**PLANNING COMMISSION MEETING STAFF REPORT**

**DATE OF MEETING:** August 9, 2022  
**NAME OF PROJECT:** Vincent Fields Small Subdivision  
**NAME OF APPLICANT:** Kevin Payne  
**OWNER:** Diane Vincent  
**AGENDA ITEM:** Preliminary/Final Approval  
**LOCATION OF ITEM:** 1315 Stringtown Road  
**ZONING DESIGNATION:** RA-1-43

**Subject: Vincent Fields Subdivision – Preliminary, Final, Annexation Review**

VINCENT FIELDS SUBDIVISION  
UTILITY PLAN

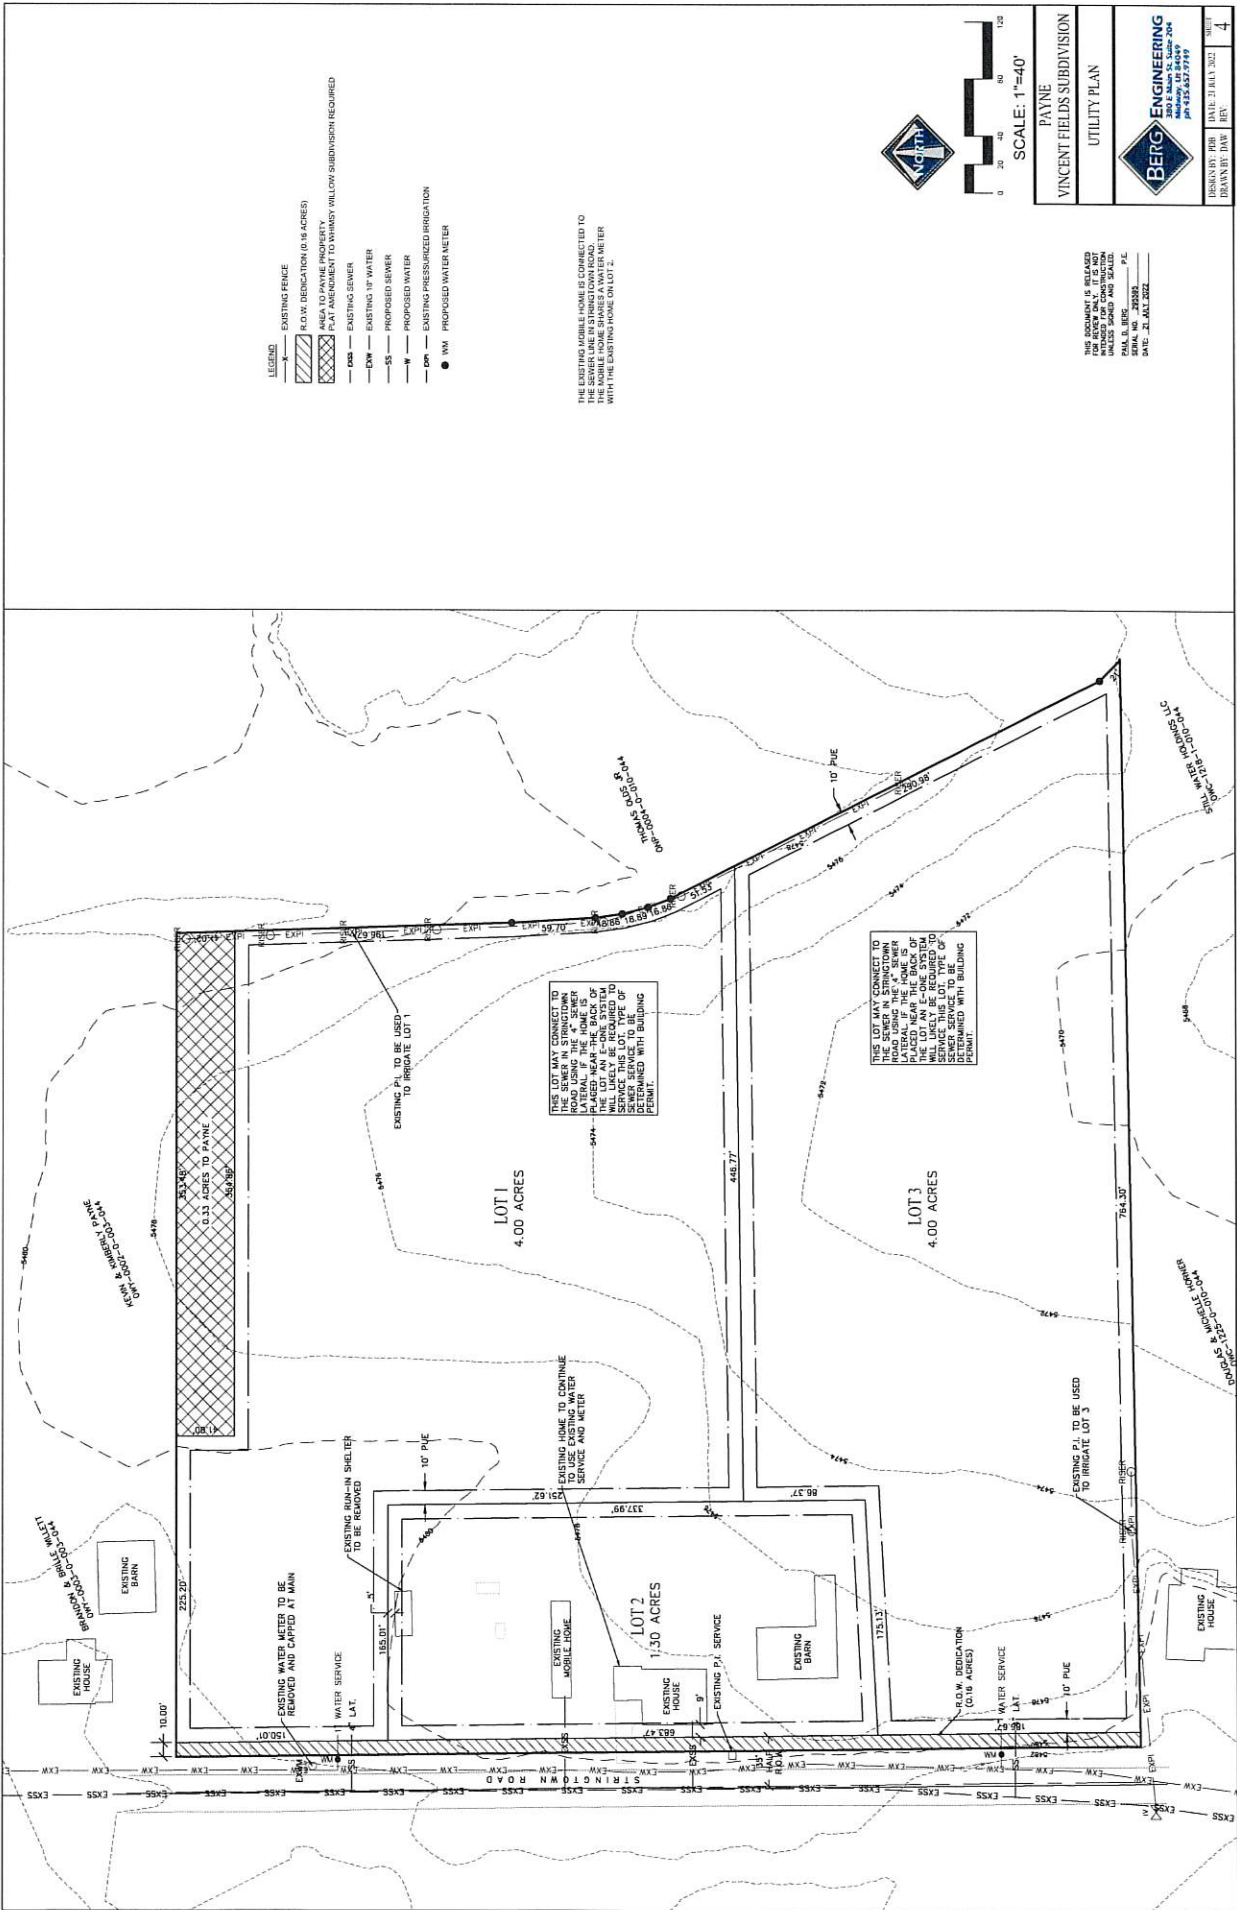
- How is sewer being provided to the existing mobile home on Lot 2?

- All existing and proposed water meters need to be shown and a discussion should be had of the water service to the existing mobile home.

THE EXISTING MOBILE HOME IS CONNECTED TO THE SEWER LINE IN STINGTOWN ROAD. THE SEWER LINE IN STINGTOWN ROAD WILL BE RELOCATED TO THE EXISTING HOME ON LOT 2.

THE LOT 1 MOBILE HOME IS TO BE RELOCATED TO THE SEWER IN STINGTOWN ROAD. THE SEWER IN STINGTOWN ROAD WILL BE RELOCATED TO THE EXISTING HOME ON LOT 2. THE SEWER SERVICE TO BE DETERMINED WITH BUILDING PERMIT.

THE LOT 3 MOBILE HOME IS TO BE RELOCATED TO THE SEWER IN STINGTOWN ROAD. THE SEWER IN STINGTOWN ROAD WILL BE RELOCATED TO THE EXISTING HOME ON LOT 3. THE SEWER SERVICE TO BE DETERMINED WITH BUILDING PERMIT.
